TECHNICAL BULLETIN

FA-A-0395-A

## **Impact on Mitsubishi Electric 40-pin Connectors (A6CON1, A6CON2, and A6CON3) Due to Connector Business Transfer of FUJITSU COMPONENT LIMITED**

### 2.1 A6CON1, A6CON2

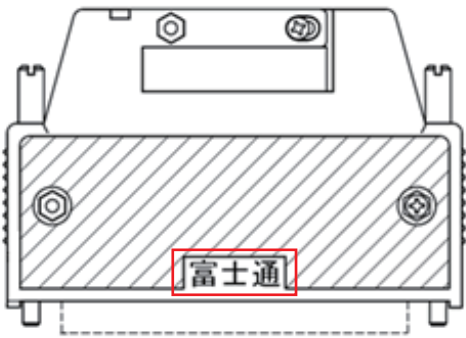
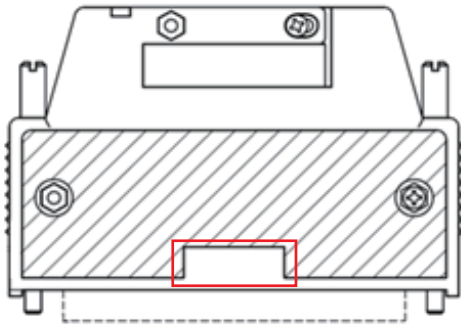
The external appearances of A6CON1 and A6CON2 are changed.

The manufacturer name is removed from those connectors.

Manufactured by FUJITSU COMPONENT LIMITED	Manufactured by OTAX CO.,LTD.
